TEP Rocky Mountain LLC
Clough 104 Pad Sundry Notice
for changes to Production Equipment
July 31, 2020

SUNDRY NOTICE

**Clough 104 Pad
Tank Battery Site Map
T6S R94W, Section 16**

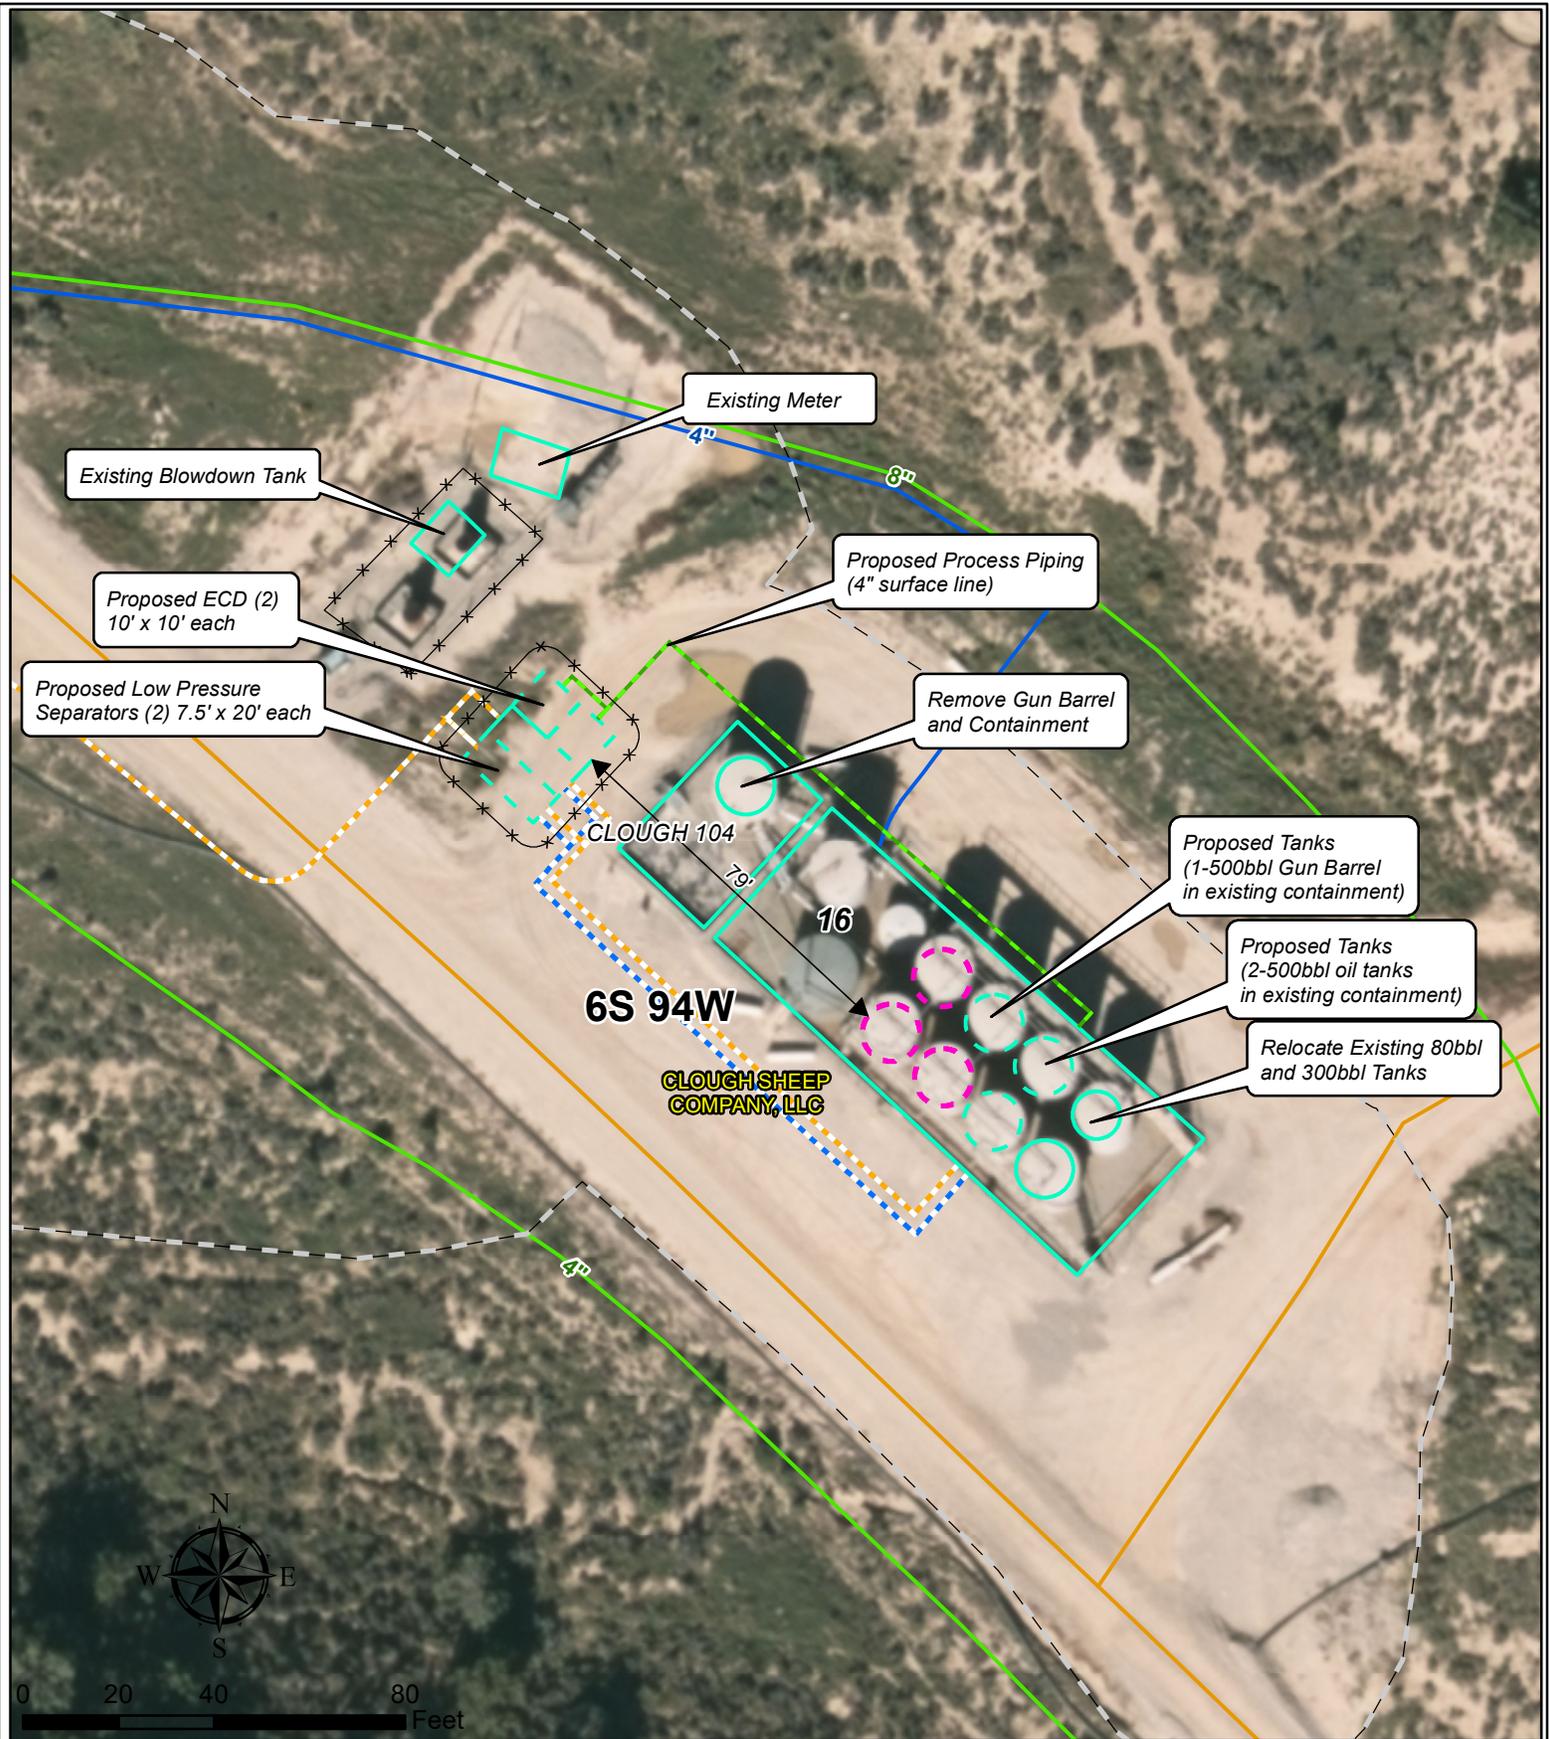
TEP Rocky Mountain LLC (“TEP”) respectfully reports the following modification to the production equipment on the Clough 104 Pad (COGCC Loc ID: 322416). TEP will install two (2) low pressure separators northwest of the existing tank battery. Two (2) emissions control devices (“ECD”) will be installed adjacent to the proposed low-pressure separators. The existing five-hundred-barrel (500bbl) gun barrel will be removed and replaced with a new five-hundred-barrel (500bbl) gun barrel within the existing containment structure (approximately 100’ x 40’). The existing twenty-foot (20’) by forty-foot (40’) containment structure will be removed as previously proposed. The existing eighty-barrel (80bbl) produced water tank and three-hundred-barrel (300bbl) produced water tank will be relocated to the southeast end of the existing tank containment to meet the minimum seventy-five-foot (75’) setback requirement. The two (2) additional five-hundred-barrel (500bbl) condensate tanks will be installed within the existing tank containment structure as previously proposed. The following outline the existing and proposed production facilities that will be located on the Clough 104 pad following completion of this work. Please see the attached site map for further details.

- Existing Wells: One (1); Well Name: Clough 104; API 05-045-06205
- Existing Meter: Two (2)
- Proposed Separators: Two (2) Separators within 15’ x 20’ area northwest of tank battery
 - Two (2) Low Pressure Separators (7.5’ x 20’ each)
- Existing Tanks: Three (3) within existing tank containment
 - One (1) 300bbl Produced Water Tank
 - One (1) 80bbl Produced Water Tank
 - One (1) 11bbl Blowdown Tank
- Proposed Tanks: Two (2) within existing tank containment
 - One (1) 500bbl Gun Barrel Tank (replaces existing gun barrel)
 - Two (2) 500bbl Condensate Tanks
- Proposed ECDs: Two (2) installed adjacent to low pressure separators.
- Future Tanks: Three (3) additional tanks may be set within the existing tank containment in the future.

- Existing Wellhead Flowline: One (1) two-inch (2”) steel (On-location Flowline)
- Existing Gas Gathering Pipeline: One (1) four-inch (4”) steel
- Existing Produced Water Pipeline: One (1) four-inch (4”) FlexPipe
- Proposed Condensate Pipeline: Two (2) two-inch (2”) FlexPipe
 - See RWF 12-9 Pad (COGCC Loc ID: 335636) Plan of Development for details on the proposed condensate pipelines.
- Proposed Production Piping:
 - Two (2) two-inch (2”) FlexPipe condensate dump lines installed from the low-pressure separators to the proposed condensate tanks.
 - One (1) two-inch (2”) FlexPipe produced water dump line installed from the low-pressure separators to the three hundred barrel (300bbl) produced water tank.
 - One (1) four-inch (4”) Aluminum process piping installed from the tank vent manifold to the proposed ECDs located northwest of the proposed tank battery.
